Development Services Staff Report for Design Review Committee

To: Design Review Committee
From: Jeff Lowe, Planner
Subject: DSRFY2016-4 – Vehicle Service Landscaping
Date: February 11, 2016

Summary: Park Hampton LLC/Hall Capital LLC, are requesting Design Review approval for landscaping associated with a Vehicle Service facility. The site is to be redeveloped as a race car shop to include preparation, repair and restoration of vehicles, a retail area for patrons, and the sale vehicles related to the operation of the shop. The 2.06 –acre site is located at 108 & 116 E. 44th Street, and 4410 & 4444 N. Osage and is within the C-2 General Commercial Zoning District, and is in the Mixed Use Commercial area of the Comprehensive Plan.

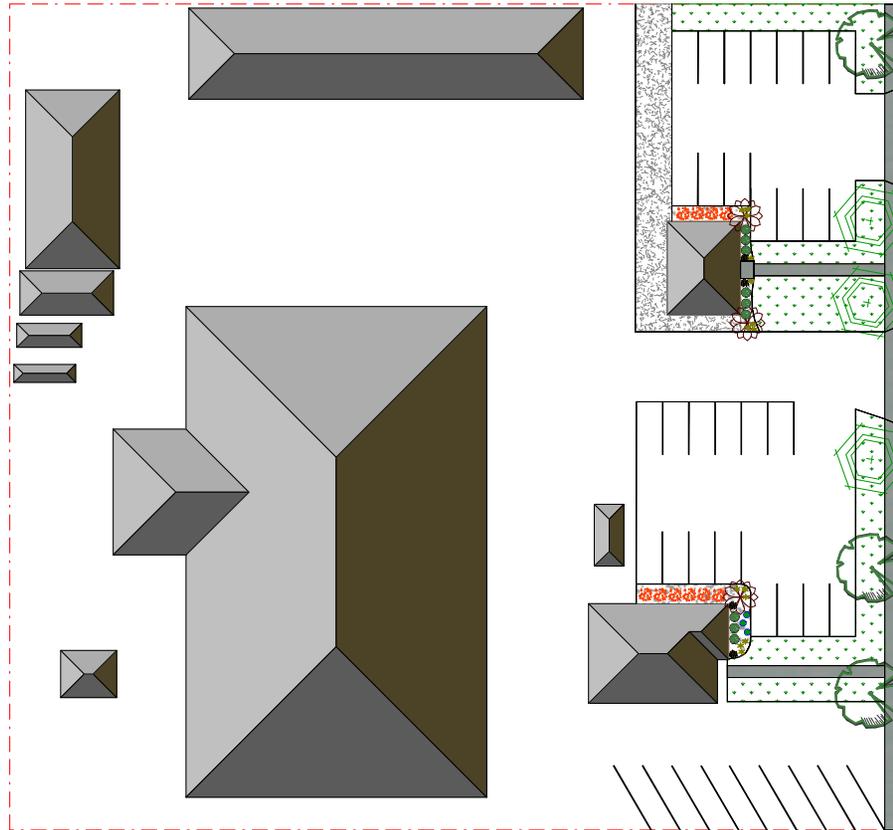
In most respects, the applicant has designed the landscaping area to be compliant with Garden City Code. The applicant has designed three parking areas adjacent to the existing structures on the site.

As noted in Garden City Code, all parking lots should be located to the side and rear of a building fronting on the street. The code allows a parking lot to be located between a building and a street when the visual effect of the parking has been mitigated. One of the methods that may be utilized to accomplish this is to provide a minimum of ten feet (10') of landscaping between the parking lot and the view from the street. The applicant does show a 10-foot wide landscape area, consisting of trees and sod, located between the back of sidewalk along 44th Street and the parking lot. **It is recommended that shrubs be planted in the landscape area to help minimize the view of the parking area from 44th Street.**

Garden City Code requires perimeter landscaping between parking areas and other paved vehicular use areas, including driveways, and vehicle storage areas and all property lines. **The applicant should install landscape areas between the south parking lot and Osage and the parking row and the central driveway (on 44th Street).**

Garden City Code requires landscaped islands with at least one (1) tree at the beginning and end of each parking row and to break up longer rows or highlight special features. **The applicant should install landscape islands on each end of the parking rows on the middle parking lot.**
